**POCATELLO CITY COUNCIL
FINAL PLAT: ASPEN PLACE
EXECUTIVE SUMMARY**

FINDINGS OF FACT AND DECISION
CITY OF POCATELLO
PLANNING AND ZONING COMMISSION
PUBLIC HEARING JANUARY 8, 2025

SUBDIVISION: Aspen Grove Subdivision
FILE: PP24-0004
APPLICANT/OWNER: David Assan of Sunrise Engineering; Gate City Builders
SURVEYOR/ENGINEER: Matt Baker of Sunrise Engineering
REQUEST: Preliminary Plat Subdivision Application
LOCATION: Four separate parcels located at 2806 S. 5th Avenue
LOTS/UNITS: Eight (8) eighteen (18) multi-family buildings; 1 common lot

Re: Aspen Grove Subdivision – City Council Final Plat (04/17/2025)
Application #FP25-0003

ATTACHMENT A
FINAL PLAT

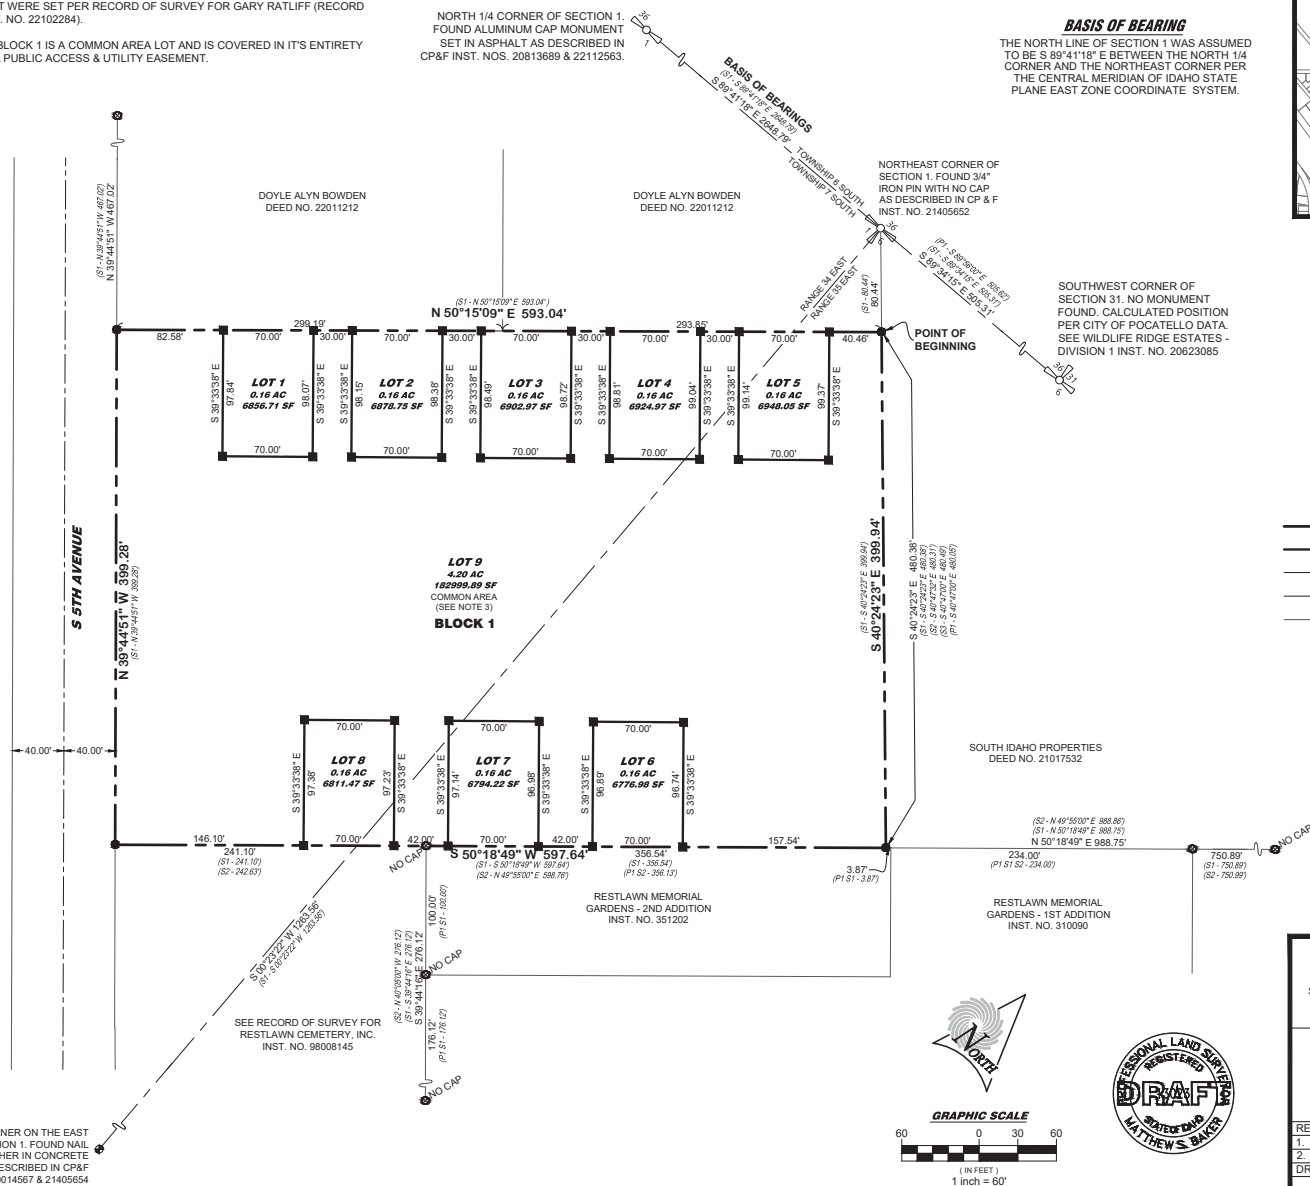
1. Plat

- A. After approval by the City Council of the proposed final plat, Applicant will be required to enter into a Development Agreement with the City of Pocatello.

- B. Prior to recording the Plat, a more inclusive and comprehensive review shall be done, coordinate all plat correction through City Surveyor.
- C. Subdivision plat shall conform to all state and local laws and ordinances.

- D. Notes on the plat shall be approved by the City of Pocatello Engineering and Legal Department prior to recording.
- E. The City of Pocatello certificate to read: The plat on which this certificate appears is hereby approved and the dedications are hereby accepted by the City of Pocatello...

- F. If there are any CCR's, indicate and place recording number on the plat. Submit any CCR's associated with this plat to the City Engineering Department after recording.

- G. Provide adjoining property owners recorded deeds, a copy of all recorded easements and document(s) which grants the signatory to sign the plat on the behalf of the owner(s) to the City Surveyor for final review.

- H. Signed copy of the Permanent Operations and Maintenance (O&M) agreement for stormwater, if stormwater system is to be private. This document will be recorded.

- I. The plat shall be reproducible on an 8.5x11 sheet of paper per Bannock County instructions. The plat shall be black opaque ink, no gray scale or color.

- J.** Add note, Easements not depicted: All lots in this subdivision are subject to a drainage easement equal to the primary structure setback line along all lot lines. Lots must be graded and maintained so as to minimize drainage to adjoining properties.

- K.** Add note, Easements not depicted: There is an easement for refuse pickup that is within the parking area. Also add this paragraph to the owner's certificate. "The undersigned owner(s) of real property located within the Aspen Grove Subdivision Plat, hereby grant permission to the City of Pocatello Sanitation Department to drive City vehicles onto the asphalt/concrete and any other private property in order to provide garbage service at the above location including vehicles needed to perform clean-up maintenance on such private property. Owner(s) release and hold harmless the City of Pocatello, a municipal corporation of Idaho, and its employees from any liability and will accept full responsibility for damages to the driving surface area, Owner(s) acknowledge and agree are beyond the control of the City of Pocatello and its employees.
